PLANNING AND ZONING AND COUNTY COUNCIL INFORMATION SHEET
Planning Commission Public Hearing Date: May 27th, 2021

Application: CU 2280 Covered Bridge Inn, LLC (Hopkins Henlopen Homestead, LLC)

FIRE PROTECTION PLAN REVIEW REPORT

Honey Bee Barn Addition
Honey Bee Barn
Hopkins Henlopen Homestead Property

PROPOSED FLOOR PLAN (OPTION #4)

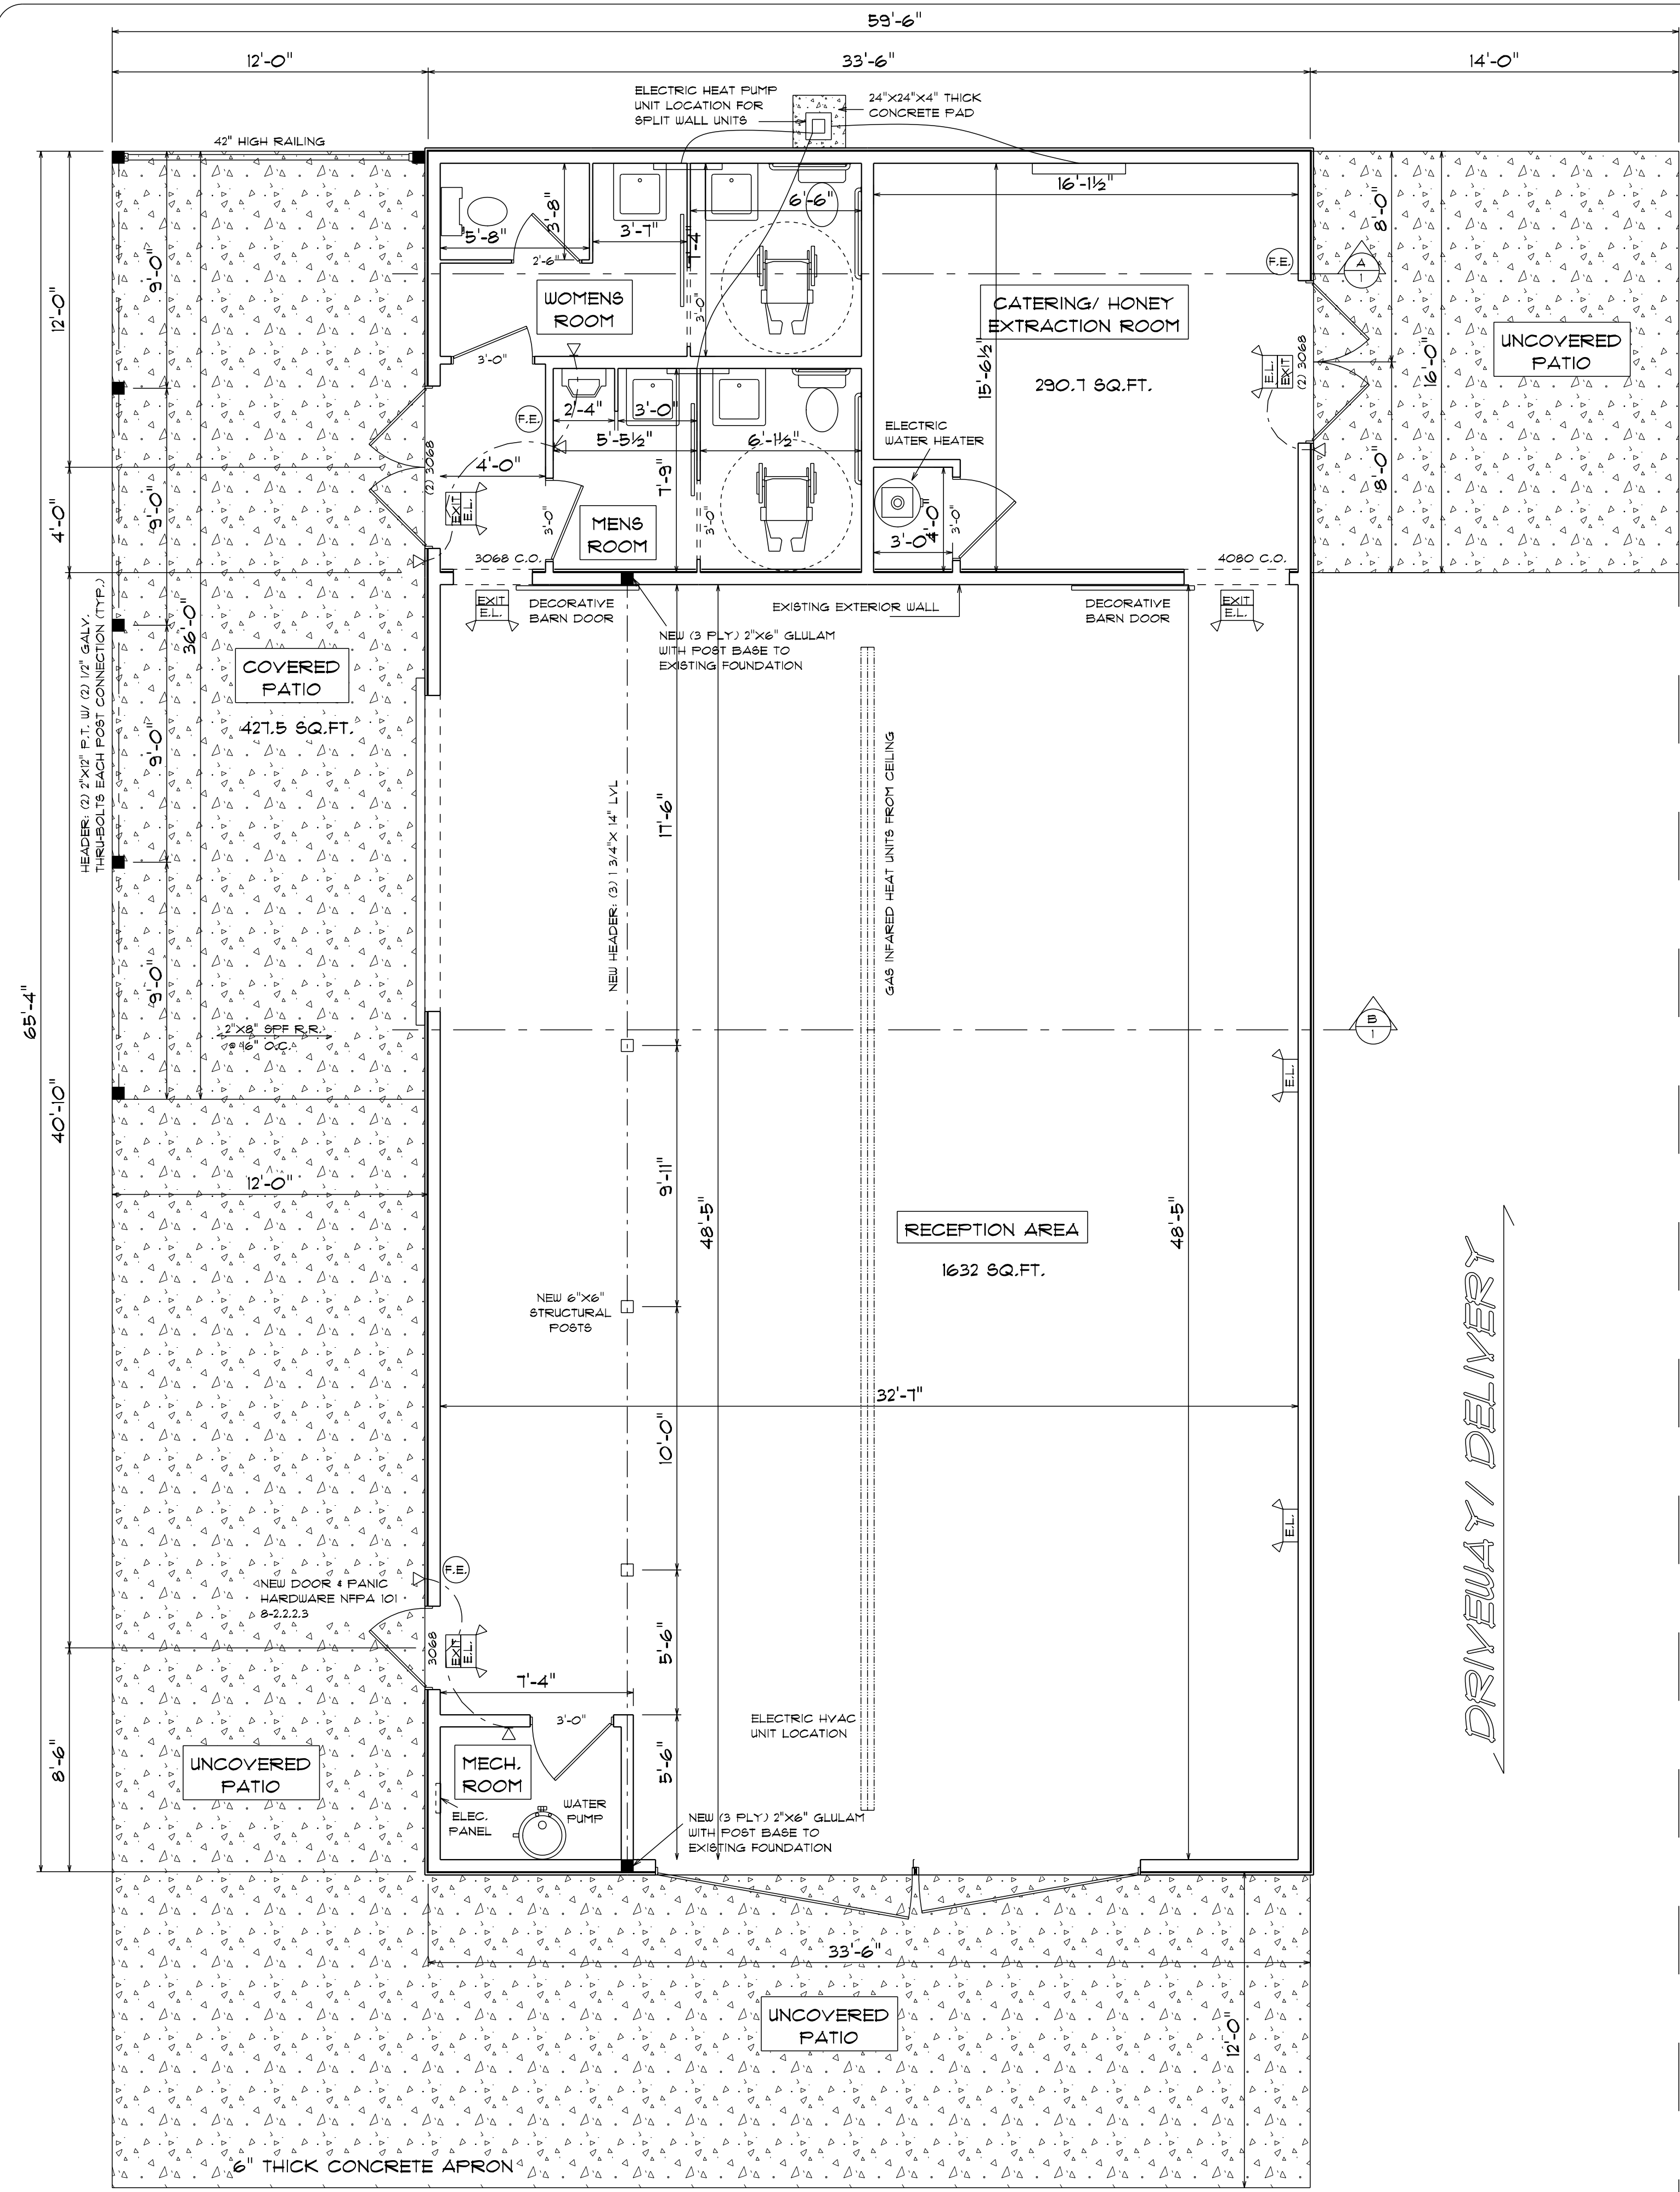
- 2050 A** Doors shall swing in the direction of exit travel (outward) where used in an exit enclosure. NFPA 101, Section 7.2.1.4.3 (2000 ed.).
- ** EXIT DOORS SHALL BE PIVOT TYPE IN ACCORDANCE WITH NFPA 101, SECTION 7.2.1.4.1. THE BARN SLIDING DOORS SHALL BE CHANGED TO PIVOT DOORS OR REMOVED. SINCE THEY ARE BOTH BEING USED AS EGRESS THE DOORS SHALL SWING TOWARD THE EXIT. IF A LATCH IS PROVIDED IT SHALL BE PANIC HARDWARE.
